Addendum No. 2
To the Plans and Specifications of

Mobile Fire Station #19
1309 Azalea Road
Mobile, Alabama 36693

Four Pages + Attachment(s)
June 26, 2025

P401

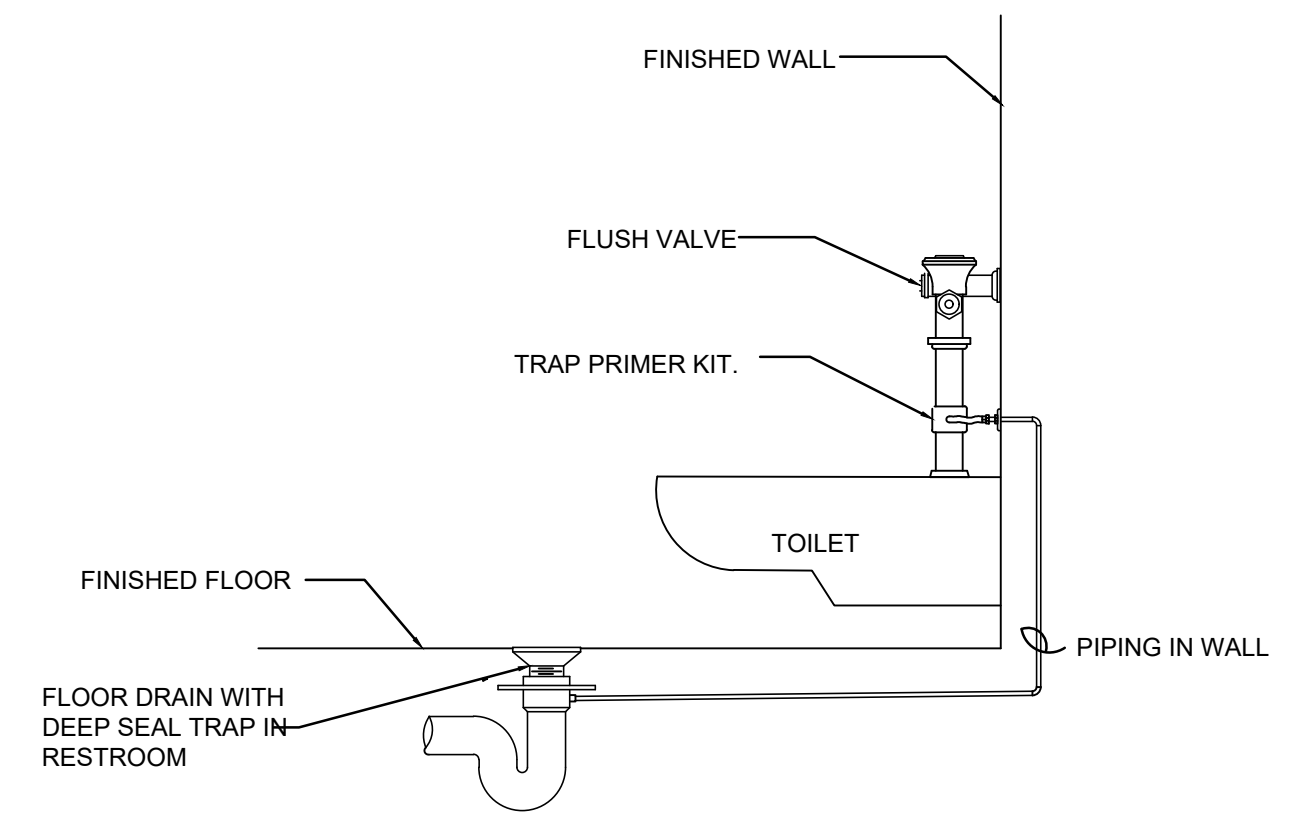
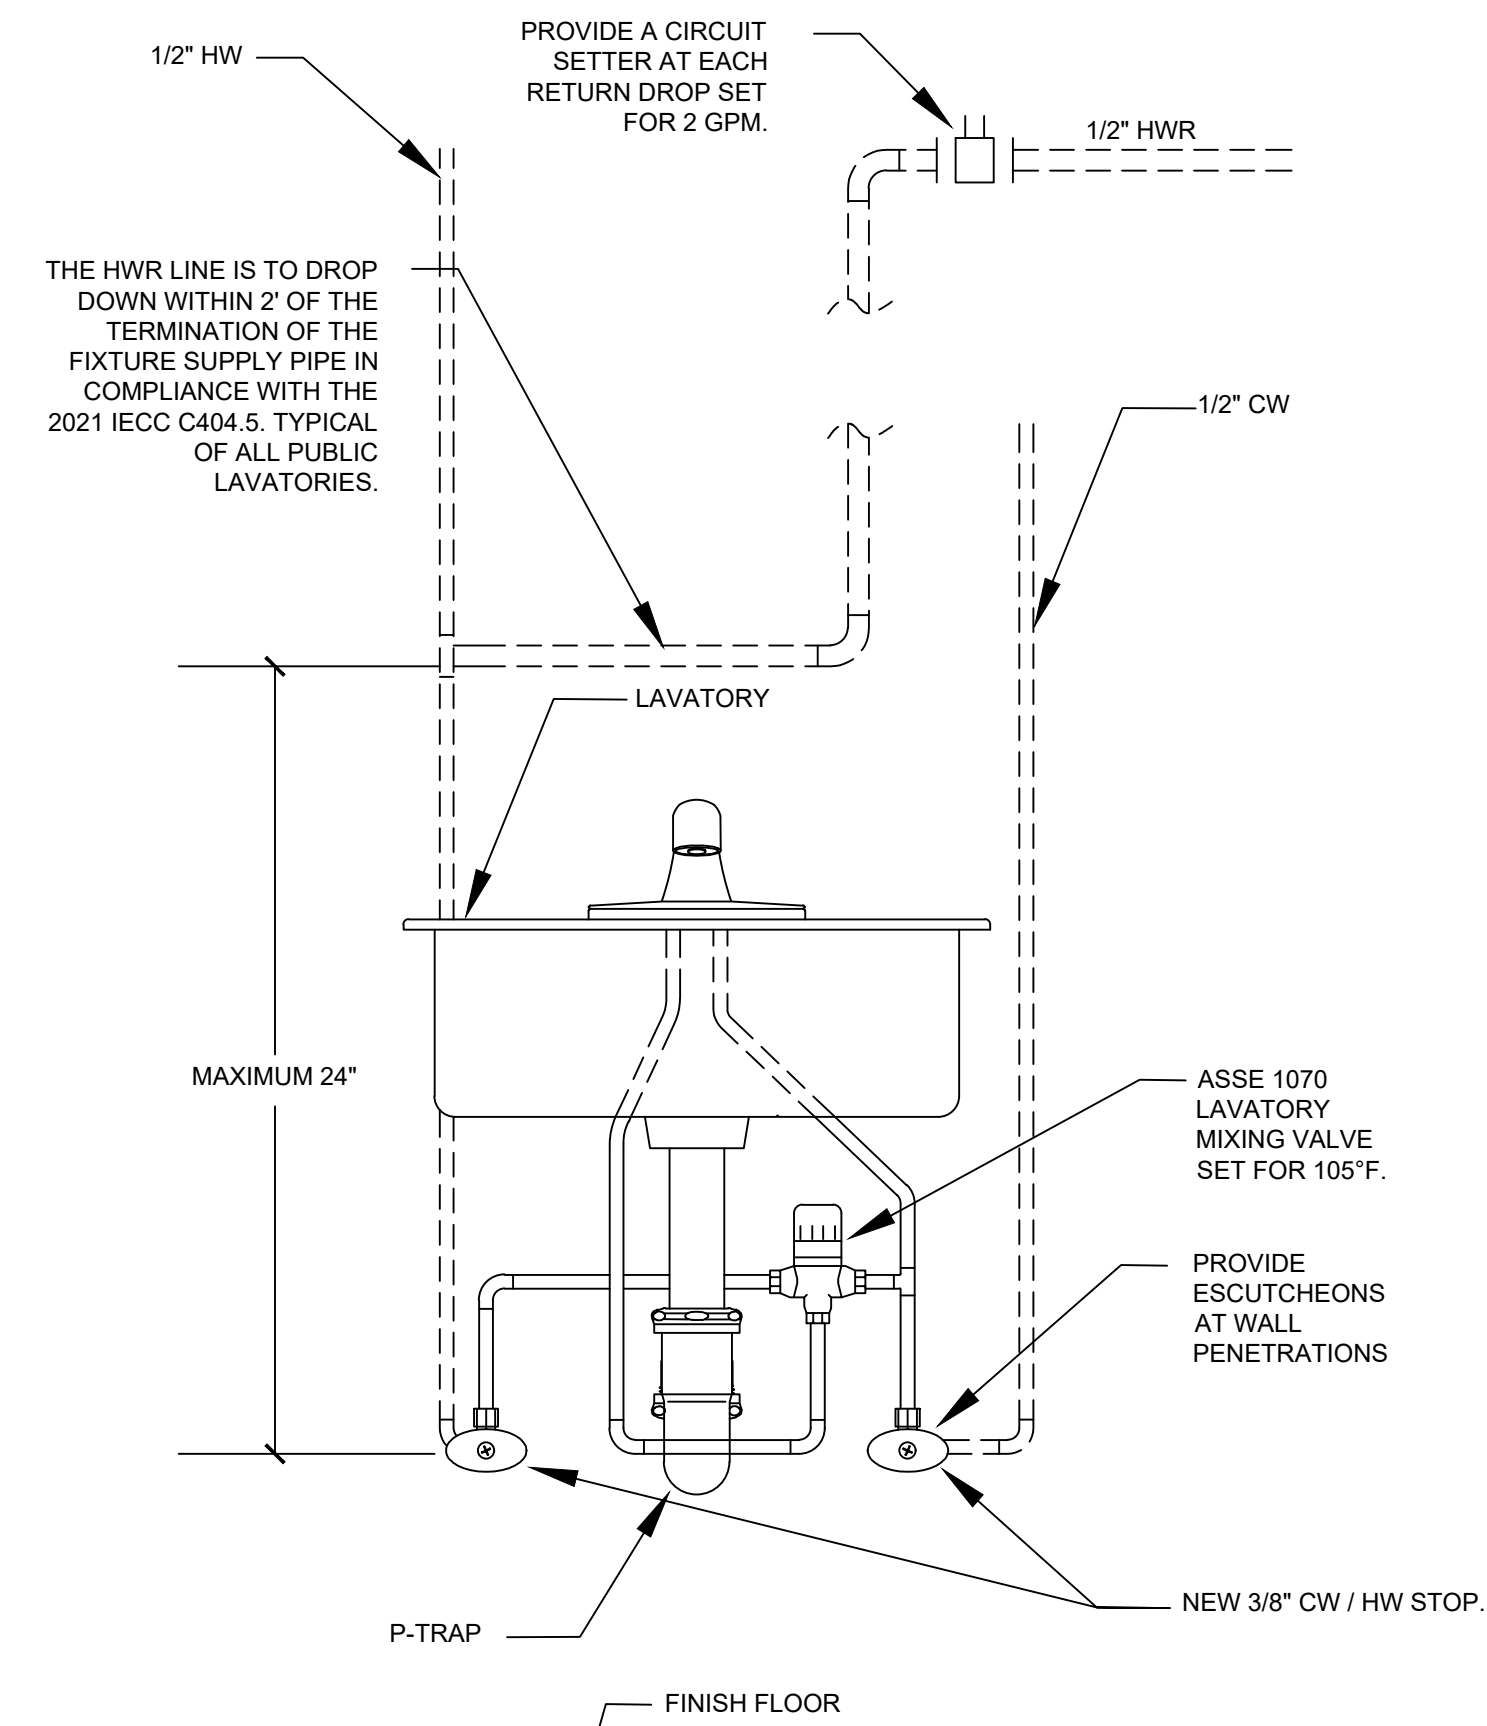
- M10. Sheet P401 – ADDED GREASE INTERCEPTOR, WATER HEATER PIPING, AND LAVATORY MIXING VALVE DETAILS.
